CITY OF ALBUQUERQUE

Re: TI @ 1430 Broadway SE
1430 Broadway Blvd SE
Traffic Circulation Layout
Engineer's/Architect's Stamp 1/24/20 (L14D062)

Based upon the information provided in your submittal received 1-24-20, the above referenced plan cannot be approved for Building Permit until the following comments are addressed:

EXISTING SITE PLAN

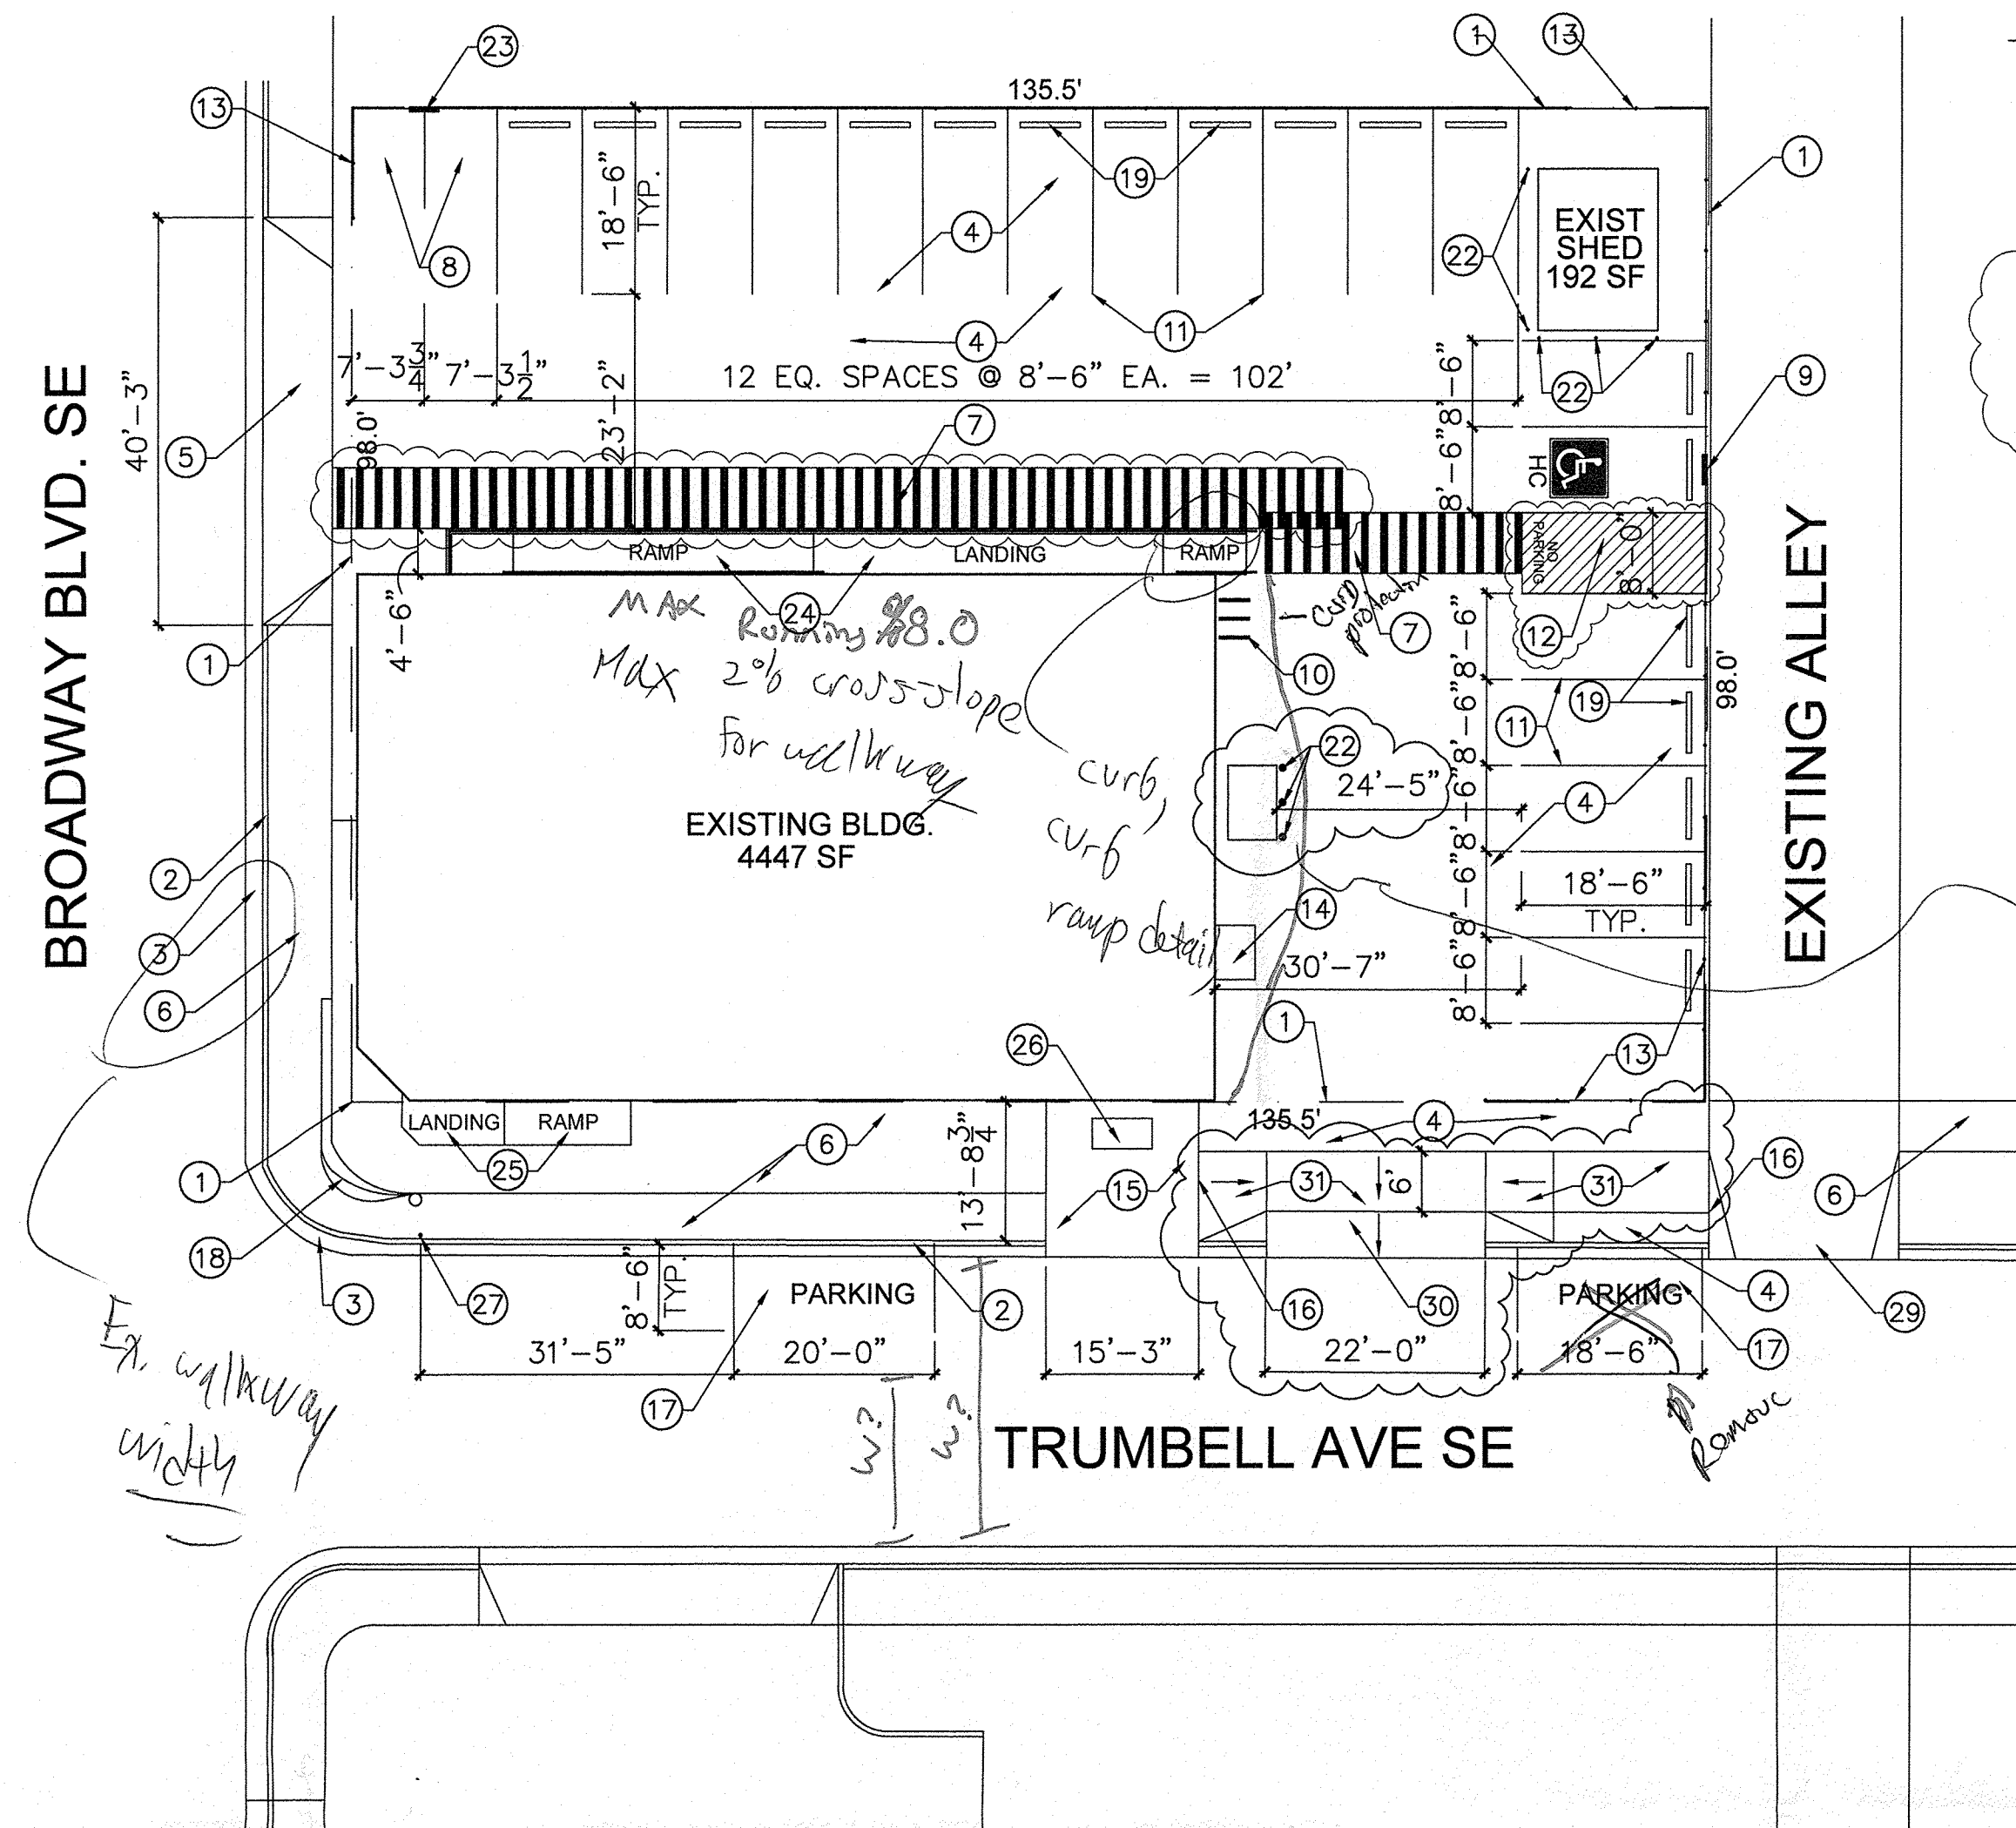
1. Please callout sidewalk width off Broadway.
2. Please callout width of Trumbell Ave SE.
3. Clarify existing property lines and proposed property lines. Property appears to have 2 addresses. (1430 & 1420 Broadway Blvd SE)

4. Parking spaces cannot cross over lot lines.
5. Please add note: The ADA access aisles shall have the words **"NO PARKING"** in capital letters, each of which shall be at least one foot high and at least two inches wide, placed at the rear of the parking space so as to be close to where an adjacent vehicle's rear tire would be placed. (66-1-4.1.B NMSA 1978)

6. Please add note for Pipe Bollard color, Yellow.
7. Service vehicle and/or refuse vehicle maneuvering must be contained on-site; provide a copy of refuse approval.

8. Please specify the City Standard Drawing Number when applicable. Add side walk standard drawing #.
9. Please include a copy of your shared access agreement with the adjacent property owner.

10. Please include a copy of the shard parking agreement with the adjacent property owner.
11. Please re-plat or provided access and parking agreements.

12. Add a note stating "All broken or cracked sidewalk must be replaced with sidewalk and curb & gutter." A build note must be provided referring to the appropriate City Standard drawing.

13. Please add ramp detail to TCL Plan. Include notes: Not to exceed Max running slope of 8.0% and Max Cross slope of 2.0%
14. Please add a curb protection. See plan for location. Bike Rack and unidentified unit protected by Bollards.
15. Please remove off street parking stall between drive access and alley.
16. Please include one copy of the traffic circulation layout at the next submittal.
